Countries:	RUSSIA, AUSTRALIA, BRAZIL, UNITED STATES, MEXICO, PUERTO RICO, NEW ZEALAND, SOUTH AFRICA	Document ID:	IK0400125
Availability:	ISIS	Revision:	2
Major System:	BRAKES	Created:	7/2/2013
Current Language:	English	Last Modified:	2/6/2015
Other Languages:	NONE	Author:	James Santos
Viewed:	363

Title: Rear S Cam Tube/ Bracket part update

Applies To: Prostar, CAT, LoneStar, Durastar, WorkStar, TranStar

Part update for cast and stamped Rear S Cam Brackets. Revised parts will include additional gusset for rear wing bracket and/ or longer gussets and wrap around weld on the flange side of the tube.

Figure #1: Cam Tube

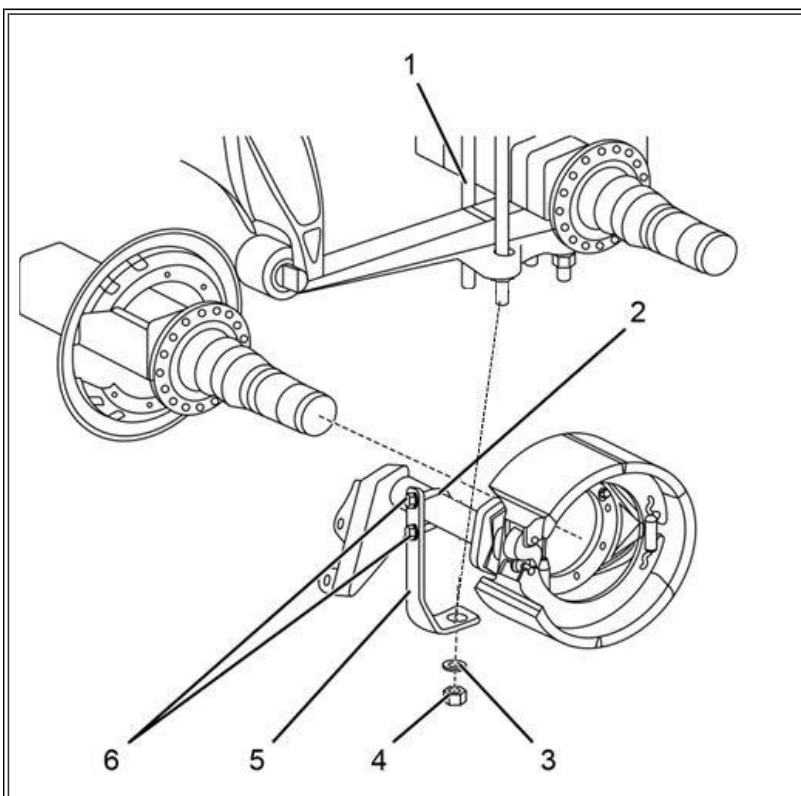
NOTE: On certain wide base axle applications the new SCAM gusseted bracket will come into contact with the old support brackets it will be necessary to order and relocate new s-cam Support bracket to the out board side of the U-bolt (Bolt closest the wheel).

1. To ensure proper installation of cam tube support bracket, perform the following:

- a. Slide new cam tube support bracket (Figure 1, Item 5) over U-bolt (Figure 1, Item 1)
- b. Position exhaust pipe clamp (Figure 2, Item 2) on cam tube support bracket (Figure 2, Item 5) and through cam tube support bracket slots with two washers and nuts

Figure # 2: Support Bracket

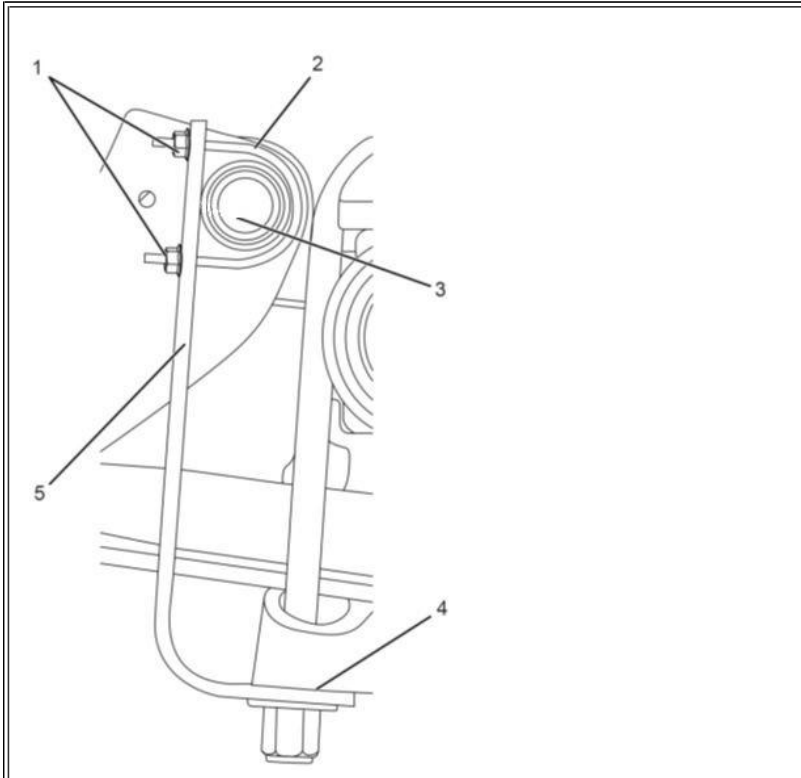
(Figure 2, Item 1) hand tight.

c. Ensure cam tube support bracket (Figure 2, Item 5) is contacting cam tube (Figure 2, Item 3) and is sitting flush against rear U-bolt spring plate (Figure 2, Item 4).

d. Using torque wrench, tighten two nuts (Figure 2, Item 1) to 60 - 72 lb-in (6.8 - 8.1 N•m).
